NO. SI 42-203

Technify Motors Service Bulletin 125-1019 P1 Rev. 1
ATA-Code: 81-00

Service Bulletin No. / Date: SB TMG 125-1019 P1, Revision 1 / September 15, 2015

Subject: Integral Exhaust Manifold

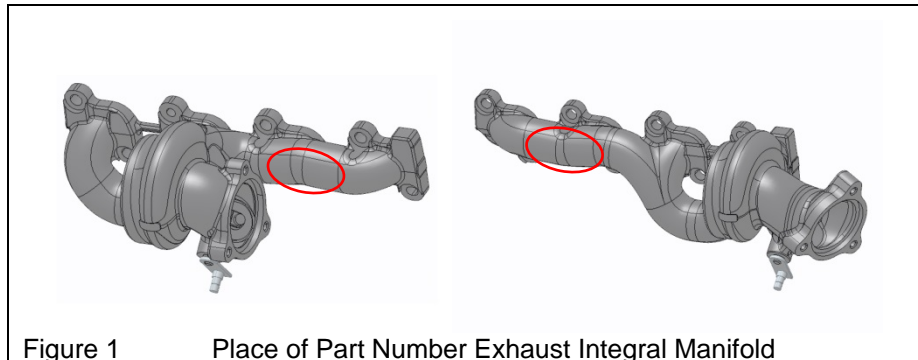
If the engines have Exhaust Integral Manifold
P/N 05-7241-K0176xx or P/N 05-7241-K0178xx
See Figure 1.

Reason: Cases of High Cycle Fatigue (HCF) of turbocharger turbine blades were reported to Technify Motors GmbH.

Installation of exhaust integral manifold P/N 05-7241-K023801 or P/N 05-7241-K023901 in accordance with RM-02-02, Chapter 72-40.03, Issue 3, Revision 2 or later approved revisions.

Installation of exhaust integral manifold P/N 05-7241-K023801 or P/N 05-7241-K023901 in accordance with RM-02-02, Chapter 72-40.03, Issue 3, Revision 2 or later approved revisions and turbocharger P/N 05-7241-K018703, 05-7241-K020302 or 05-7241-K019402 in accordance with RM-02-02, Chapter 72-40.01, Issue 3, Revision 1 or later approved revisions.
